To: T10 Technical Committee
From: Tim Symons, PMC-Sierra (Tim_Symons@pmc-sierra.com)
Date: 5 September 2008
Subject: 08-360r2 SAS-2 ZONE GROUP VALID bit

Overview

Figure 56 – Zoning expander route table

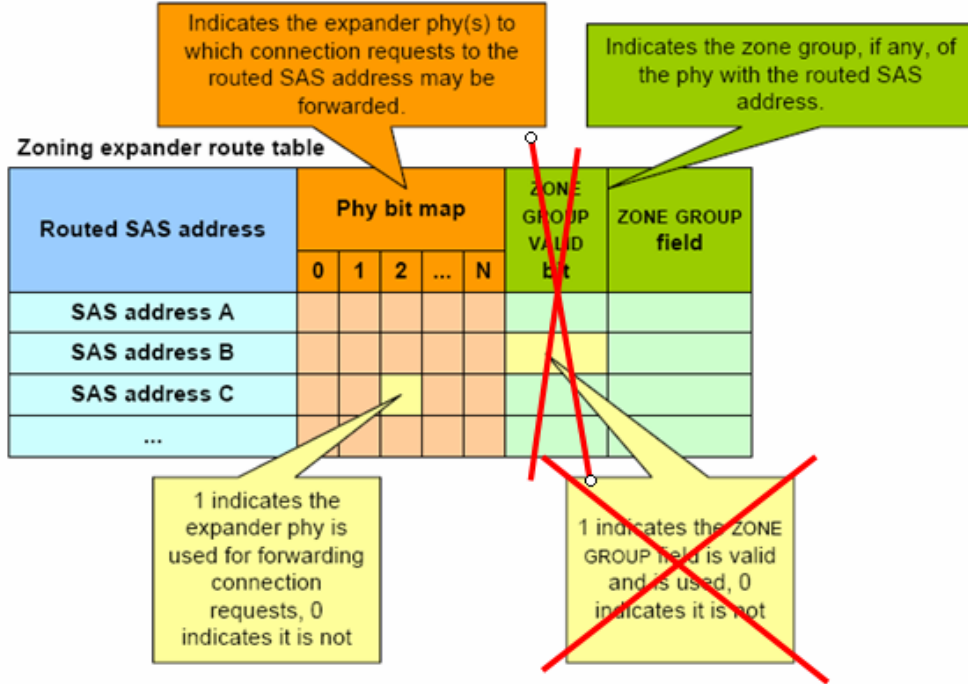
Other references for the ZONE GROUP VALID bit are in Figure 56 and Table 34 but both references are confusing and unnecessary.

Editors note : If zoning is enabled then the ZONE GROUP field is valid else it is not.
